SUPPLEMENTAL INSTRUCTION

PROJ.: Turnbull School
Music Room Addition
PROJ. No.: 1705
DATE: March 1, 2019
S.I. No. S.I. - 016

New Ceilings in Existing Corridor

SI-016.01

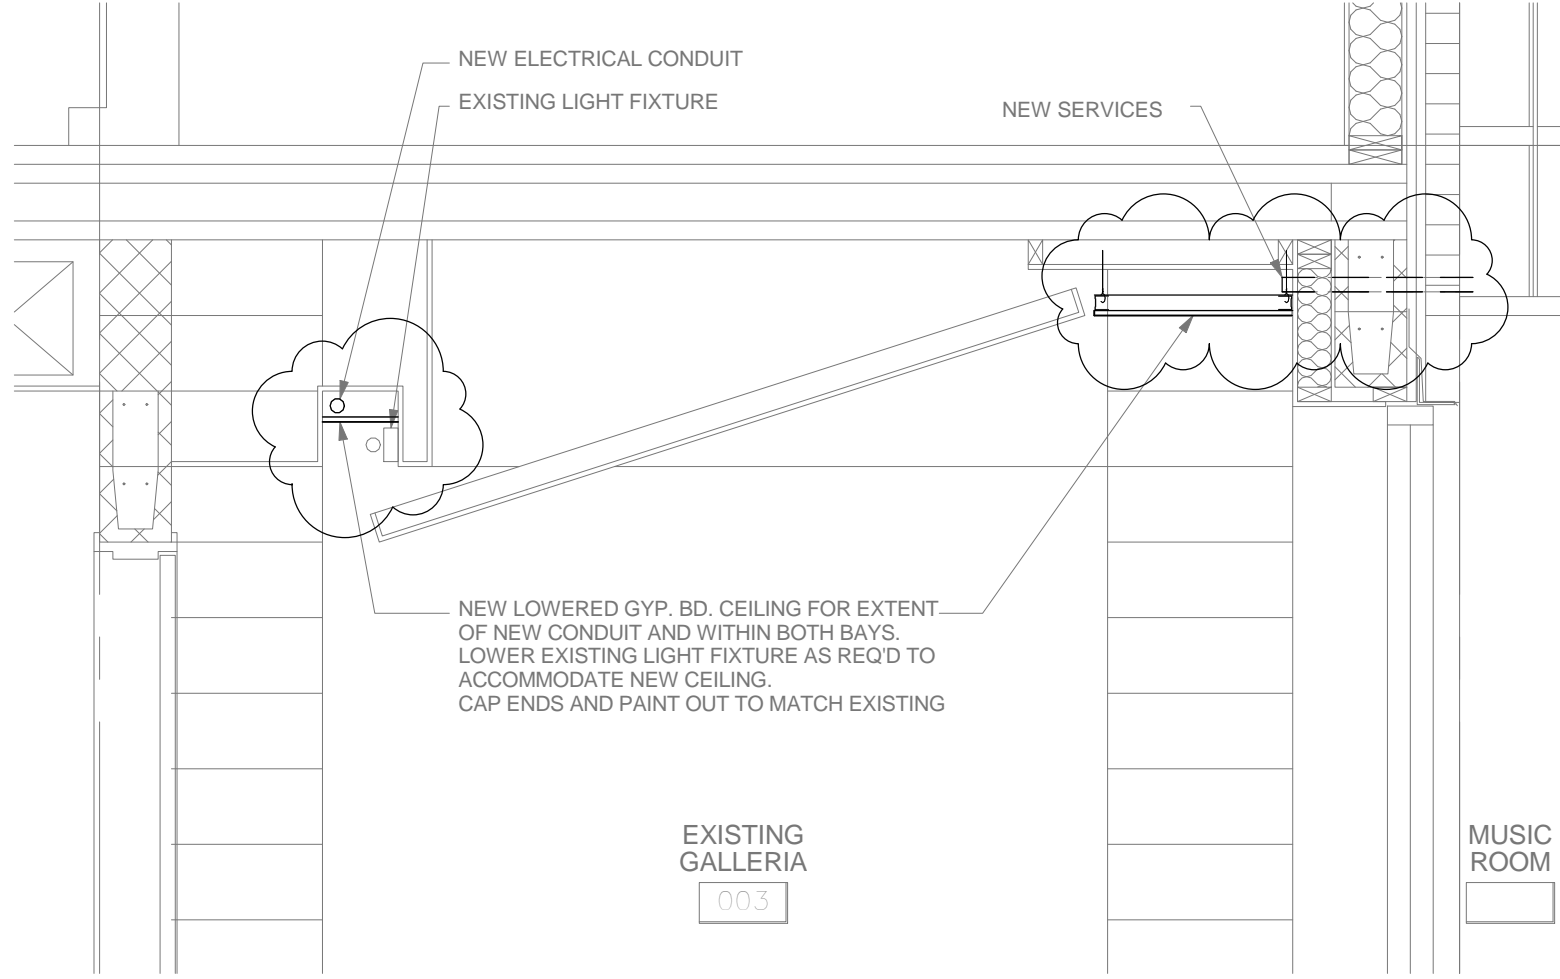
.1 Refer to the attached Architectural Sketch SI-016.01 for detail to provide ceilings in corridor to conceal new services. New ceiling to run length of new electrical conduit and within both bays.

NEW LOWERED GYP. BD. CEILING FOR EXTENT OF NEW CONDUIT AND WITHIN BOTH BAYS. LOWER EXISTING LIGHT FIXTURE AS REQ'D TO ACCOMMODATE NEW CEILING. CAP ENDS AND PAINT OUT TO MATCH EXISTING
